American Transportation Corporation

RECALL NOTICE

AMERICAN TRANSPORTATION RECALL # 01302
NHTSA RECALL # 01V-241

Issue: Heater/Defroster Motor Excessive Operating Current

Serial Number

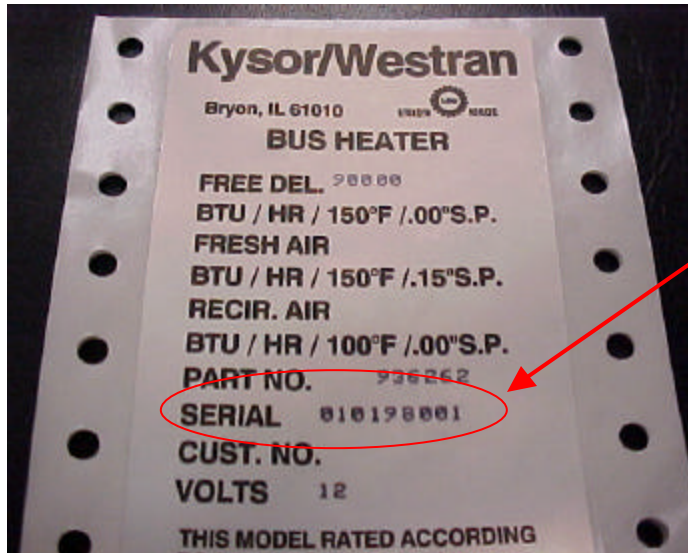
Step # 1. Verify that the heater system installed in this unit is involved in this recall.

- Inspect the serial number on the Kysor Westran I.D. label located on the cover of the unit. (See picture below.)
- The first six digits of the serial number are the date in MMDDYY format. Example: (010198) January/1st/98.

- If the date is not between Jan 01, 1998 and June 30, 2000, return the “AUTHORIZATION FOR RECALL SERVICE” card with box # 1 checked (Inspected – No corrections necessary). This bus does not require repair and we will document that the inspection has been performed.
- If the date is between Jan 01, 1998 and June 30, 2000, proceed to step # 2.
